91V-137

SUBJECT: IMPORTANCE OF RECALL REPAIRS

Subject: Recall Campaign MBNA Number 91-0913
Replacement of Parking Brake Grip - 190 Model

SUBJECT: MODEL 201
REPLACEMENT OF PARKING BRAKE GRIP

Figure 1

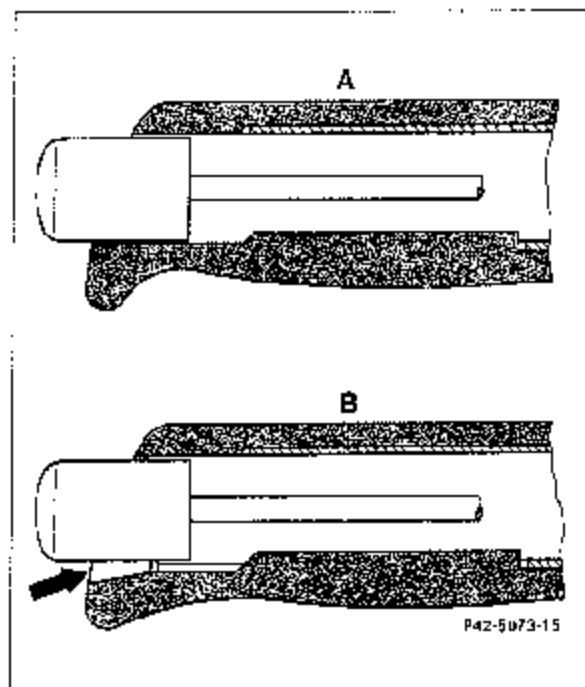
This campaign is initiated because MBNA has found that the grip for the parking brake lever in the subject vehicles produced up to the end of 1987, under certain conditions, can pinch and hold the release knob while the lever is being raised to apply the parking brake. When the release knob is pinched by the grip, it can prevent complete engagement of the parking brake mechanism.

As of the beginning of 1988, a modified grip is installed with greater play in the release knob area (arrow, Figure 1), effectively preventing the grip from pinching the release knob when raising the parking brake lever.

The modified parking brake grip must be installed in all vehicles built prior to the beginning of 1988 within the Effective Serial Number Range on page 2.

1. Remove old grip from parking brake lever by twisting slightly and pulling off. Make sure that the cover on the lever stays clipped onto the hook of the lever.
2. Without using any lubricant, push new grip onto lever by twisting it back and forth until grip almost reaches stop on plastic cover of hand brake lever.
3. Using the old grip as an aid, drive new grip onto lever until it reaches the stop.
